Drawing No. 37

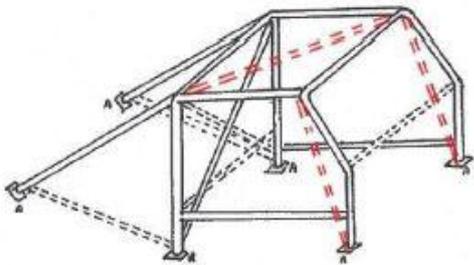
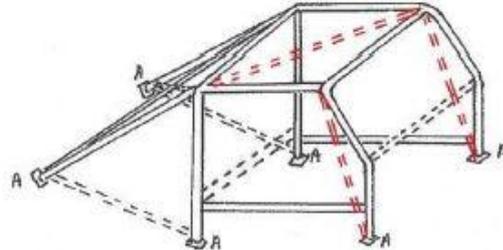
Doorbars may alternatively be as shown in figure 12(g) or (h). **Roof Reinforcement may alternatively be as shown in figure 10(a) to 10(d)**

Reason: As a result of Rallies Committee's proposal to require Roof Reinforcement and Windscreen Pillar Reinforcement. Drawing No. 37 needs to be amended to allow these additional ROPS bars in a historic stage rally vehicle.
